MIL-B-46506D
AMENDMENT 6
04 January 1994
SUPERSEDING
AMENDMENT 5
18 March 1991

MILITARY SPECIFICATION

BOXES, AMMUNITION PACKING,
WOOD, WIREBOUND

This amendment forms a part of Military Specification MIL-B-46506D, dated 30 August 1984, and is approved for use by all the Departments and Agencies of the Department of Defense.

FIGURE 1

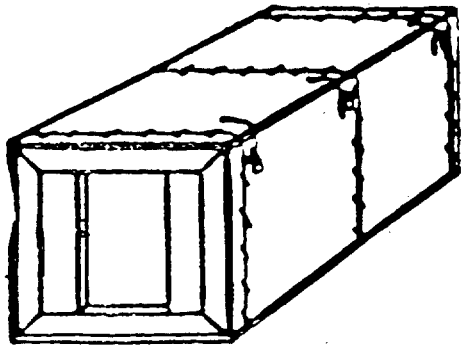
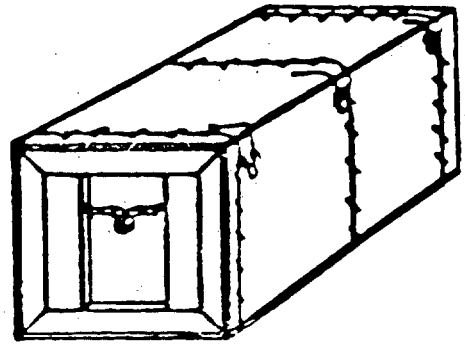
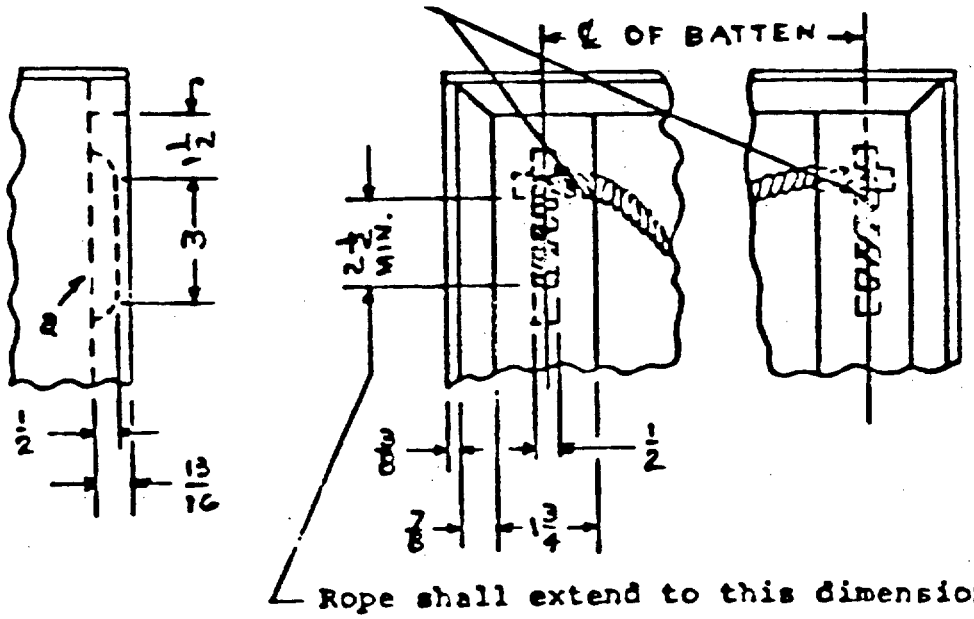
Figure 1: Delete in its entirety and substitute the included Figure 1.

FIGURE 1A.

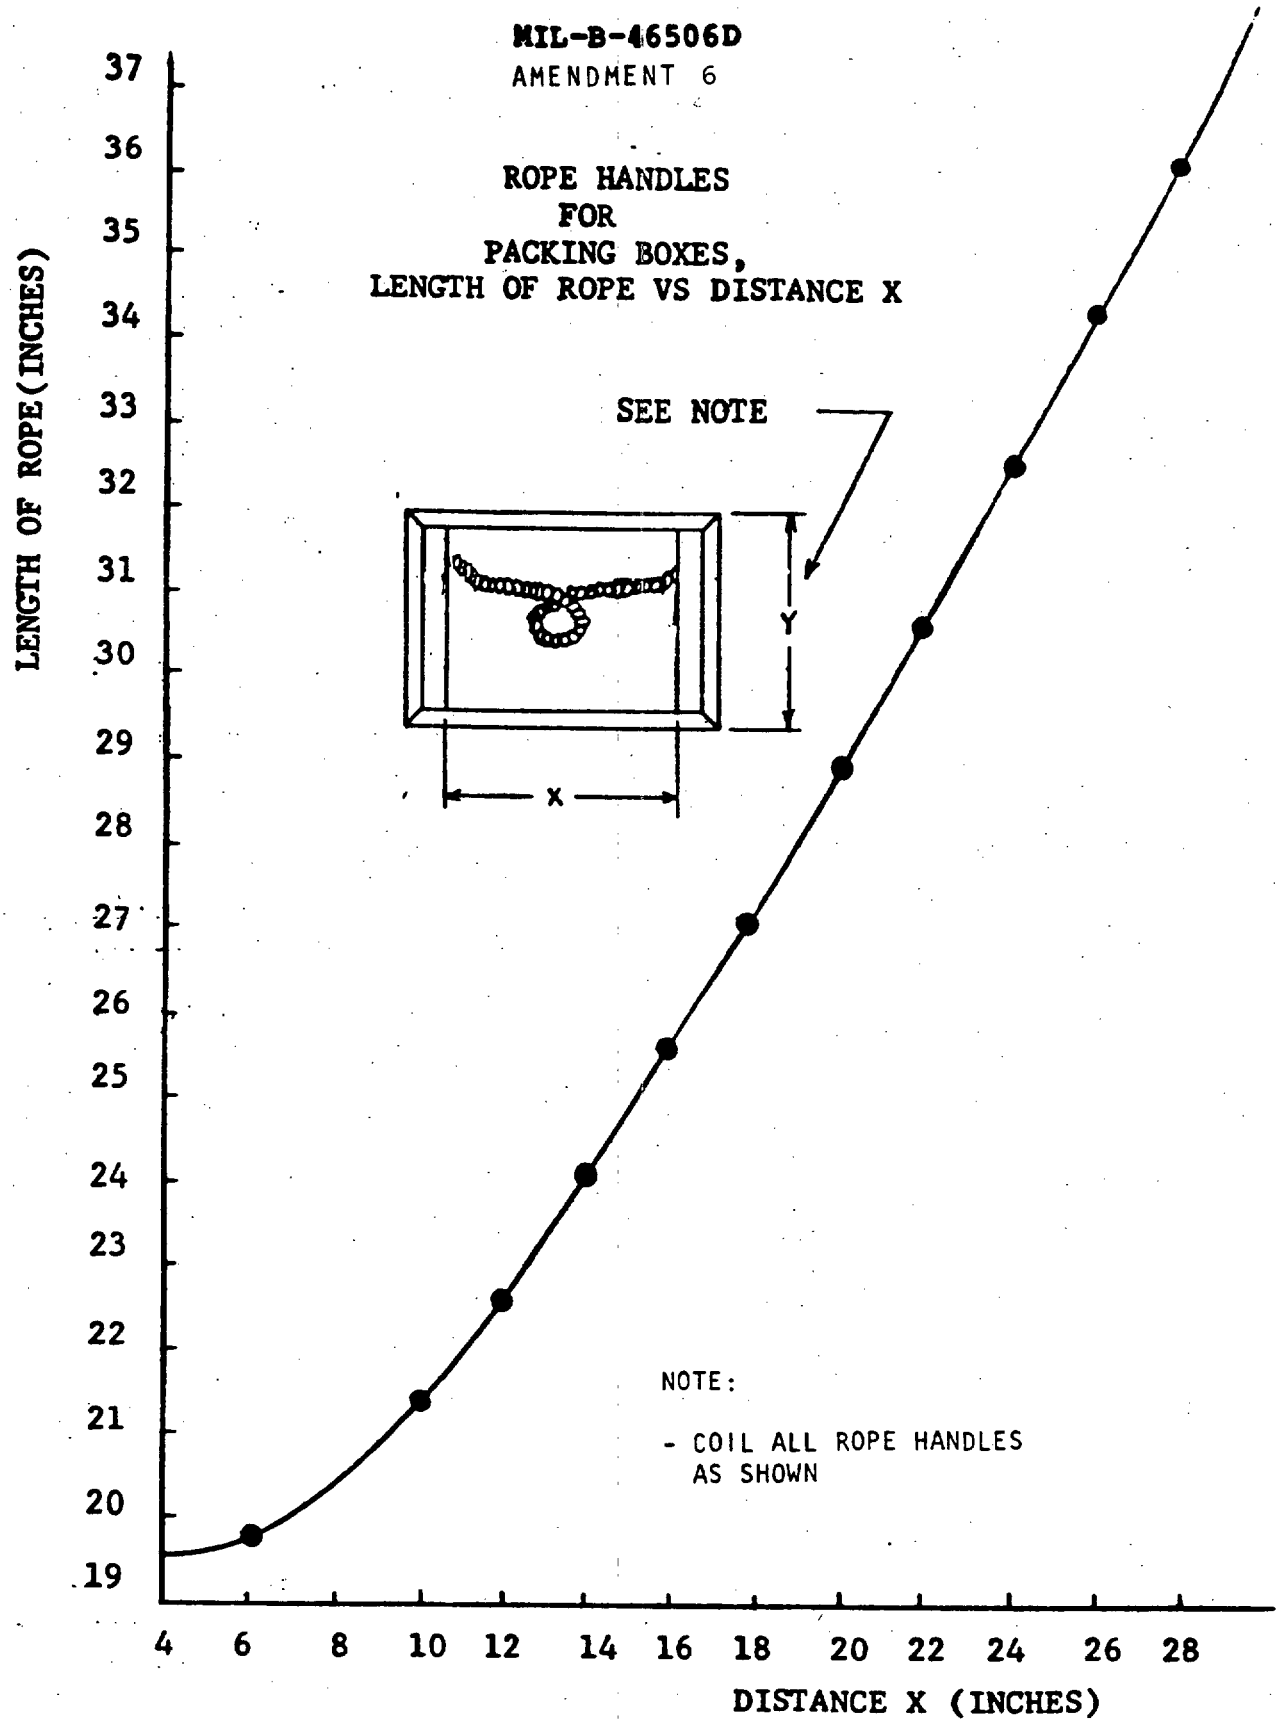
Figure 1A. Delete in its entirety and substitute the included figure 1A.

FIGURE 5

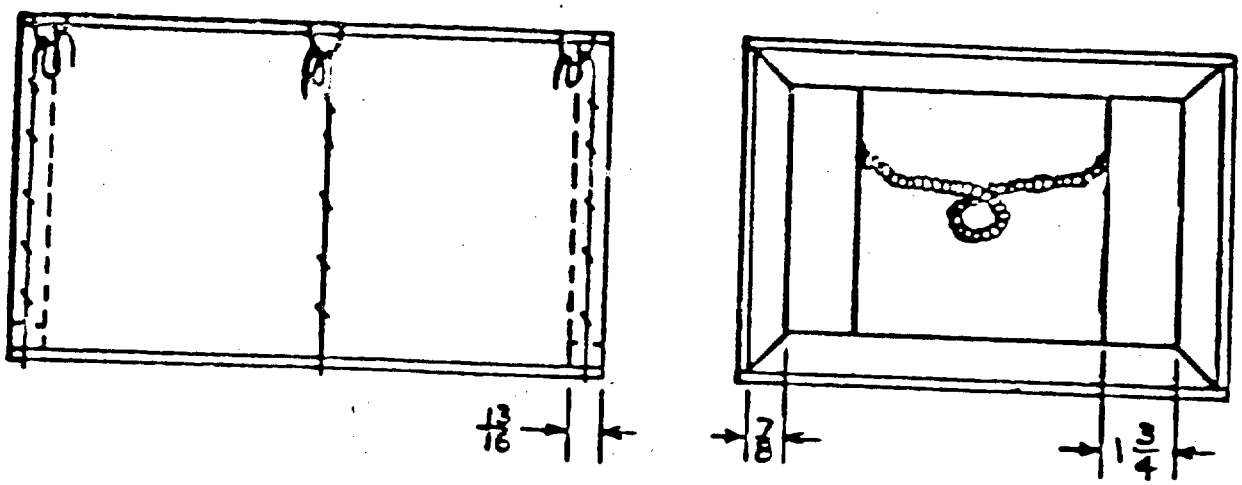
Figure 5: Delete in its entirety and substitute included Figure 5.
